PlanGrid Task Report - Jul 25, 2025

#339 Existing AC-2: Inaccessible damper

#338 Existing Hood-1: Capture jet speed controller is not functional

Sheet
M1.1

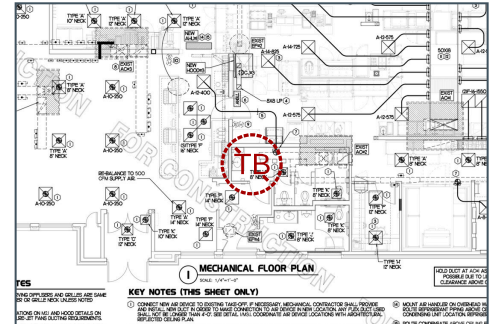
Description
Unable to access damper for SGRD 2-2 (lobby supply diffuser) due to the restroom hard ceiling. Supply diffuser is currently 117% above design.

The attached pictures do not show that an accessible damper has been installed. Task re-opened. Once an accessible damper is installed and documented a return trip will be scheduled to rebalance this unit.

AC-2 to be rebalanced during return trip.
